PCN# : P684AAB  
Issue Date : Aug. 18, 2016

### Information Only Notification

Figure 10. Maximum Continuous Drain Current vs. Case Temperature

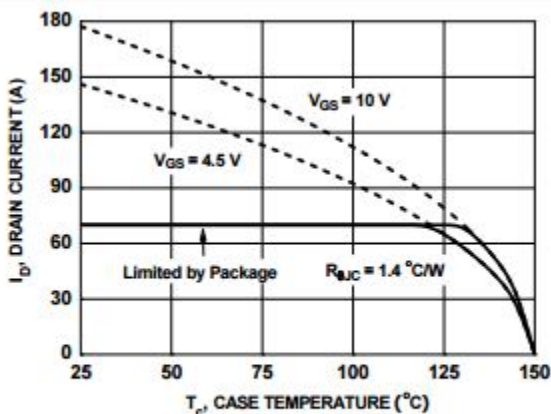
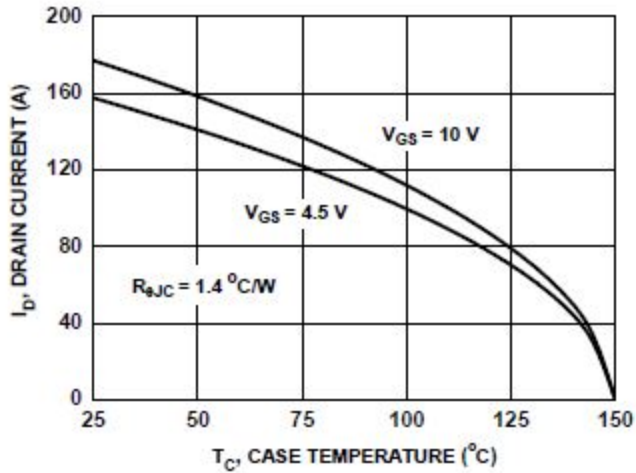
- Figures 11, 12 and 13 (Safe Operating Area (SOA) and Thermal curves based on Theta-JA data. (Page 4,5)
- Figure 10 had the package limit datapoint (page 4)
- MOSFET Maximum Ratings - ID (Drain Current) - (page 1)
  - no continuous ID at 100C
  - 25C Continuous Rating = 70 A
  - Pulsed ID = 150 A.

1. Figures 11, 12 and 13 (Safe Operating Area (SOA) and Thermal curves updated to be based on Theta-JC data. (Page 4,5)
2. Remove package limit from Figure 10 as the package limit test is not ideal test (page 4)
3. MOSFET Maximum Ratings - ID (Drain Current) - (page 1)
  - a) Continuous Id added at 100C with rating of 112 A
  - b) 25C Continuous Rating = 176 A
  - c) added Notes 5 and 6
